Form 3160-5
(June 2019)UNITED STATES
DEPARTMENT OF THE INTERIOR
BUREAU OF LAND MANAGEMENTFORM APPROVED
OMB No. 1004-0137
Expires: October 31, 2021**SUNDRY NOTICES AND REPORTS ON WELLS**
Do not use this form for proposals to drill or to re-enter an abandoned well. Use Form 3160-3 (APD) for such proposals.

8. Well Name and No. ANTERO 14 FED COM/502H

9. API Well No. 30-025-50615

EOG respectfully requests an amendment to our approved APD for this well to reflect the following changes:

WELL LOCATION AND ACREAGE DEDICATION PLAT

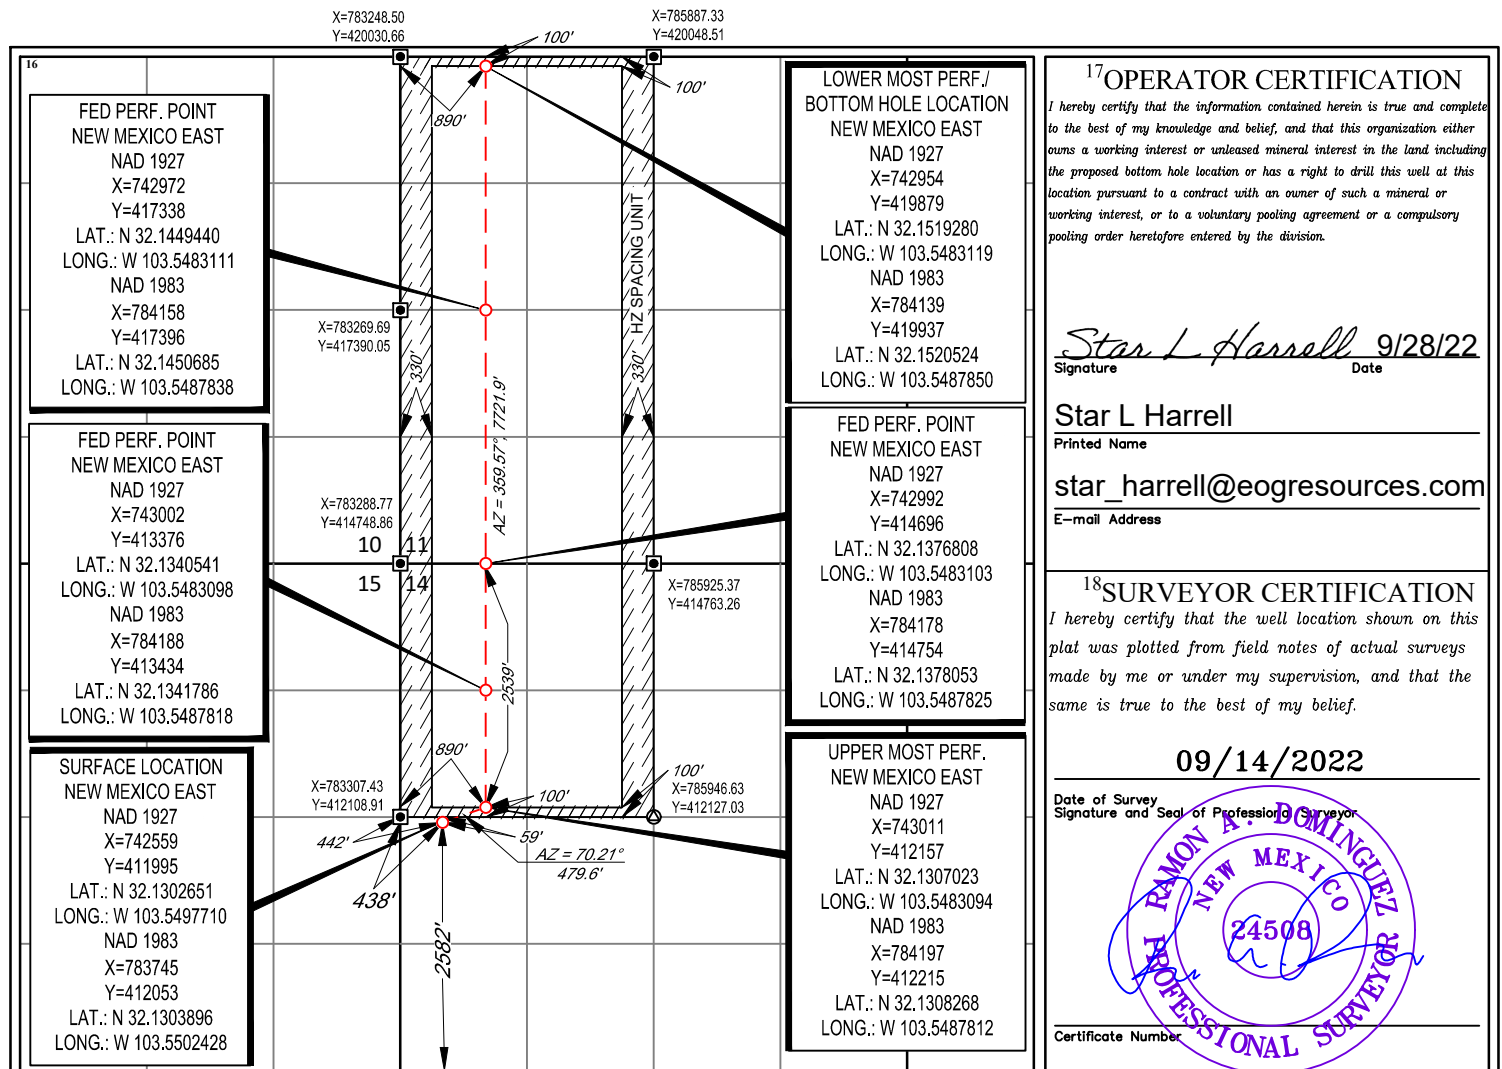
Change BHL from T-25-S, R-33-E, Sec 11, 100' FNL, 772' FWL, Lea Co., NM, to T-25-S, R-33-E, Sec 11, 100' FNL, 890' FWL, Lea Co., N.M.

UL or lot no.	Section	Township	Range	Lot Idn	Feet from the	North/South line	Feet from the	East/West line	County
D	11	25-S	33-E	-	100'	NORTH	890'	WEST	LEA
